# Product Change Notification

PCN #: 5C-2018

DATE: 10<sup>th</sup> May 2018

Laird Part Number	Description
BL652-SA-01	Bluetooth v5 Module + NFC (Integrated Antenna)
BL652-SC-01	Bluetooth v5 Module + NFC (External Antenna)
BL652-SA-01-T/R	Bluetooth v5 Module + NFC (Integrated Antenna) – Tape & Reel
BL652-SC-01-T/R	Bluetooth v5 Module + NFC (External Antenna) – Tape & Reel
DVK-BL652-SA-01	Development Kit - Bluetooth v5 Module + NFC (Integrated Antenna)
DVK-BL652-SC-01	Development Kit - Bluetooth v5 Module + NFC (External Antenna)

Figure 1: Module label

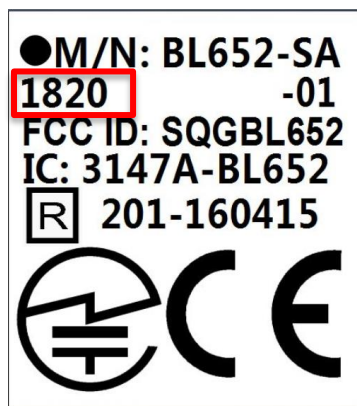
The change can be identified by reviewing the **Build Code** number that is present on the individual module, reel label and carton label. The images below identify where this **Build Code** is located on each of those labels.

A Build Code that starts with **1820**, and all subsequent incremental numbers, indicates that the nRF5283-QFAA-E00 silicon is utilised.

Label examples shown are for the -SA versions, all -SC versions follow the same format.
